FINAL DRAINAGE REPORT

FALCON RANCHETTES FILING NO. 2
MERIDIAN STORAGE
El Paso County, Colorado

Add PCD File No.
VR239

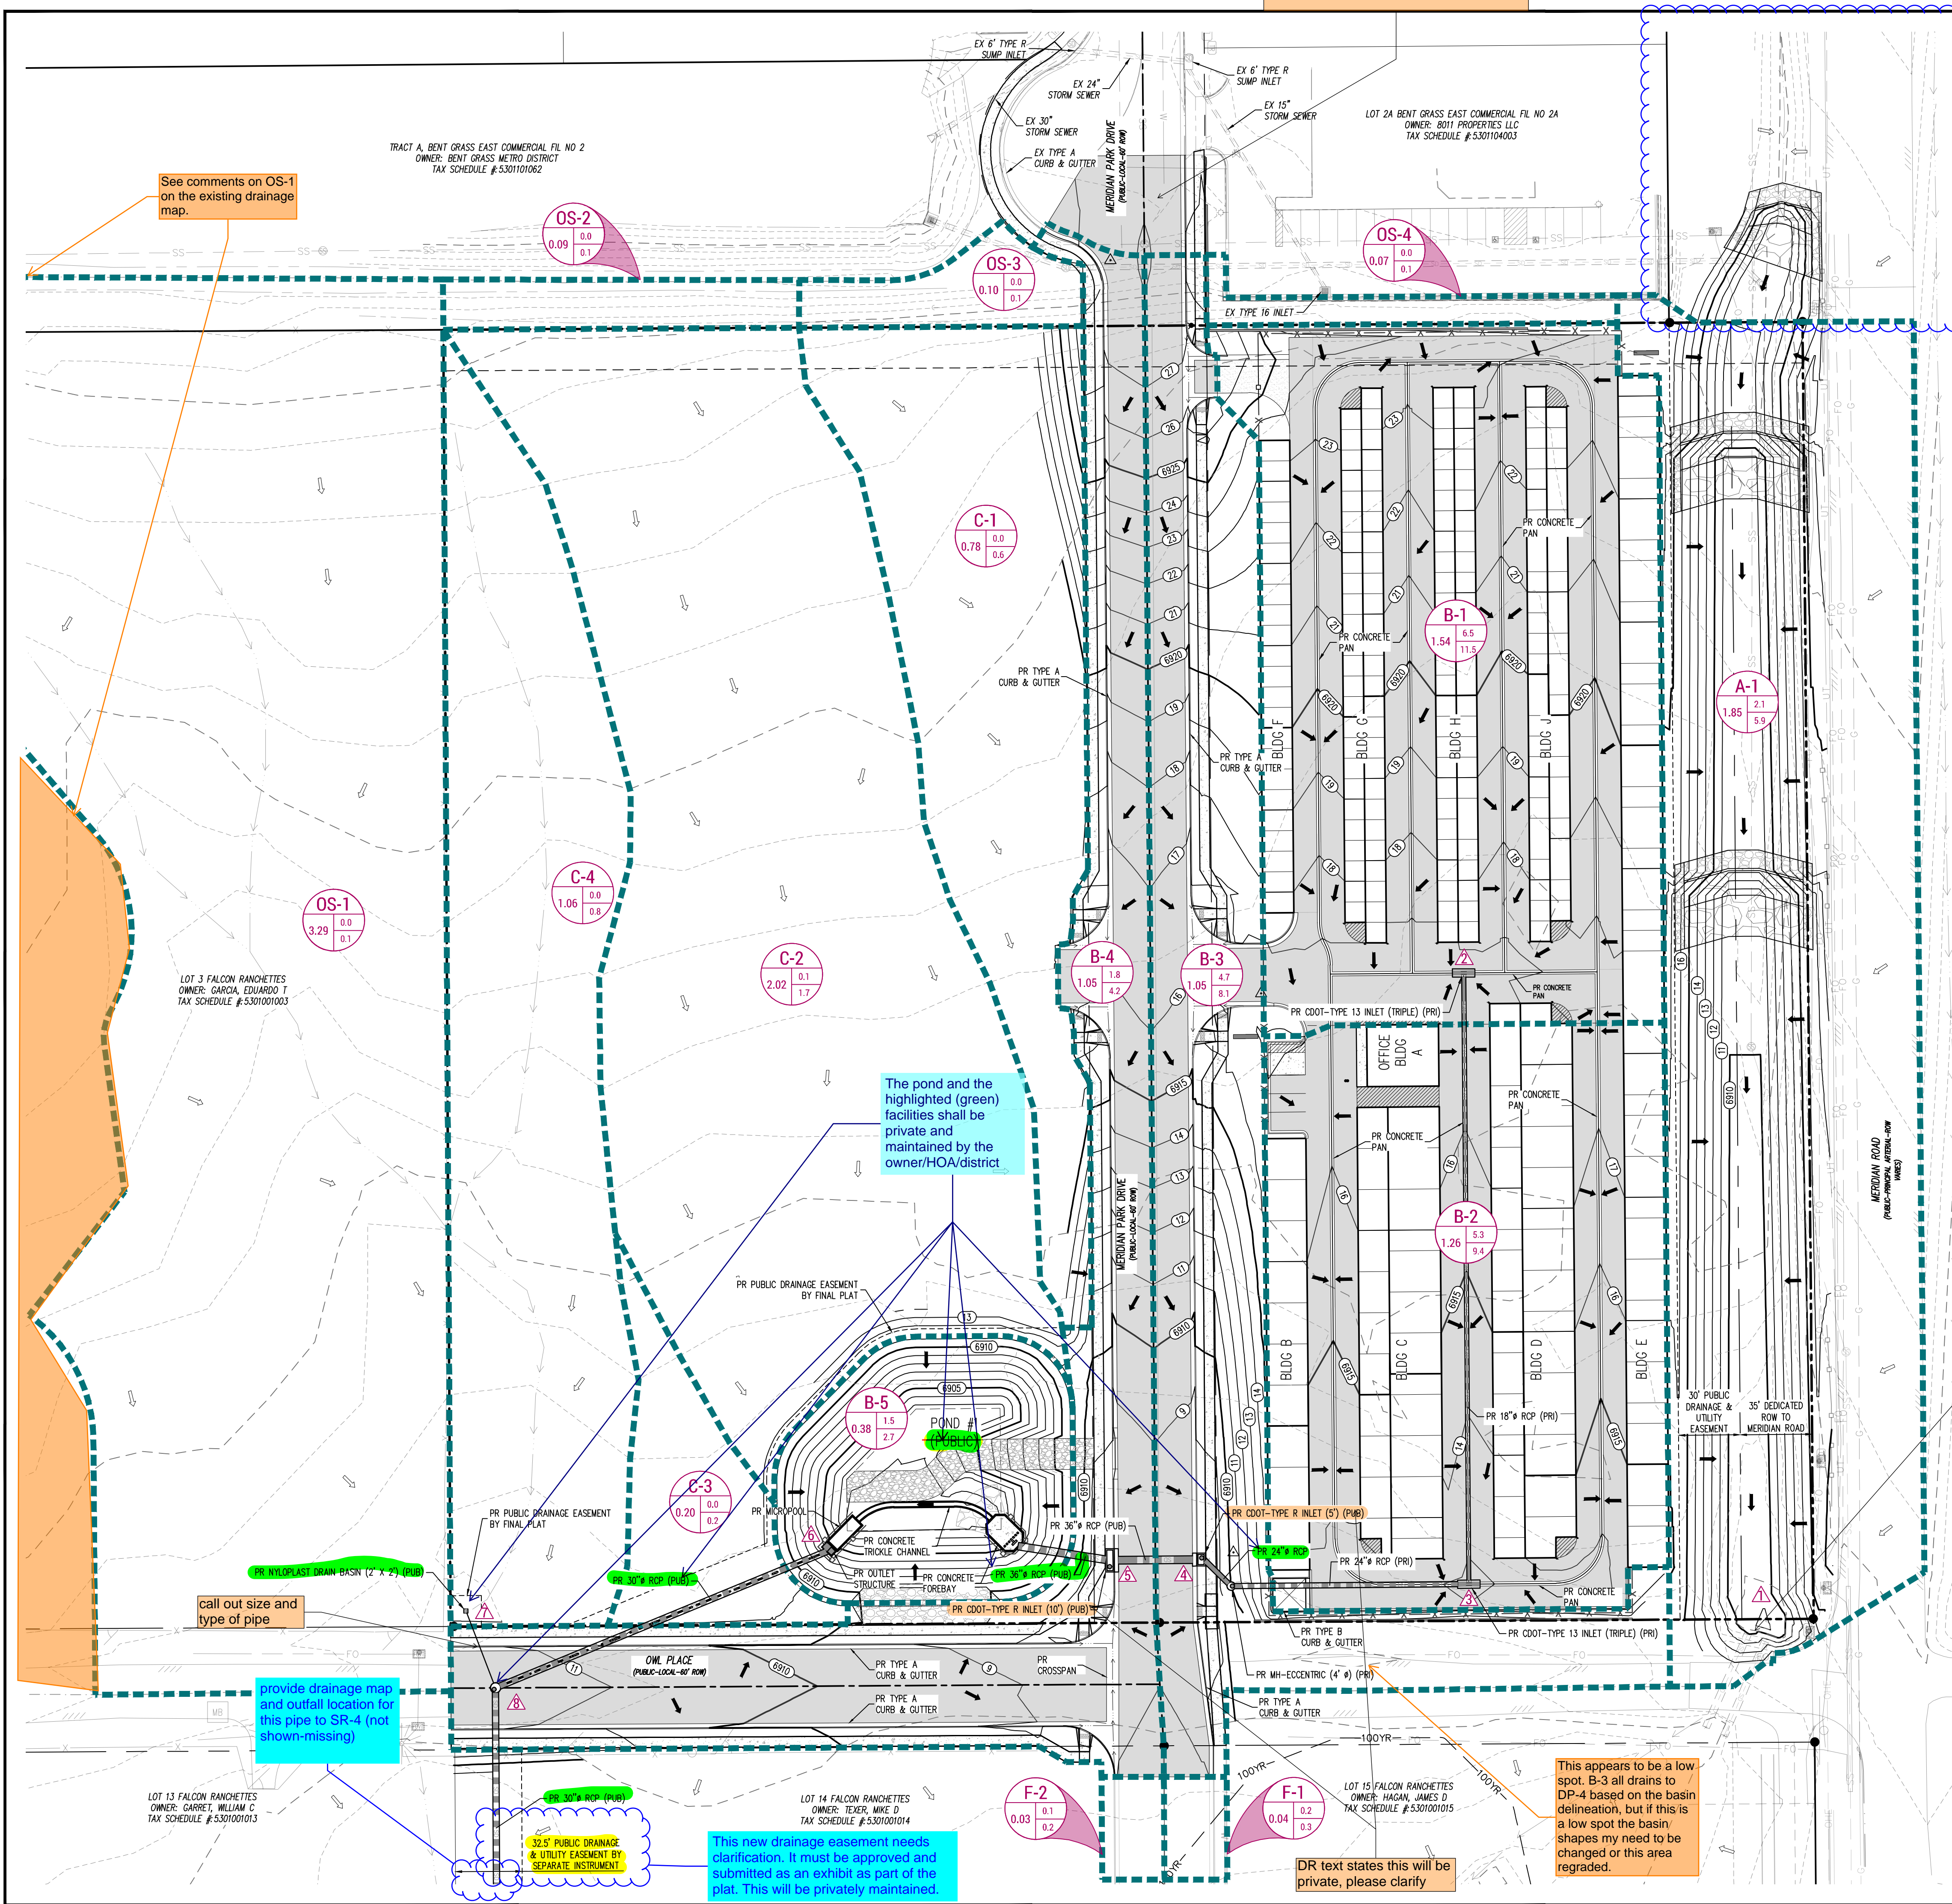
Per the narrative B-3 basin flow will be conveyed to the inlet yet the design point does not account for all of Basin B-3 flow. Please verify and revise accordingly. update pipe flow that may be affected as well.

See comments on OS-1 on the existing drainage map.

The pond and the highlighted (green) facilities shall be private and maintained by the owner/HOA/district

provide drainage map and outfall location for this pipe to SR-4 (not shown-missing)

DR text states this will be private, please clarify
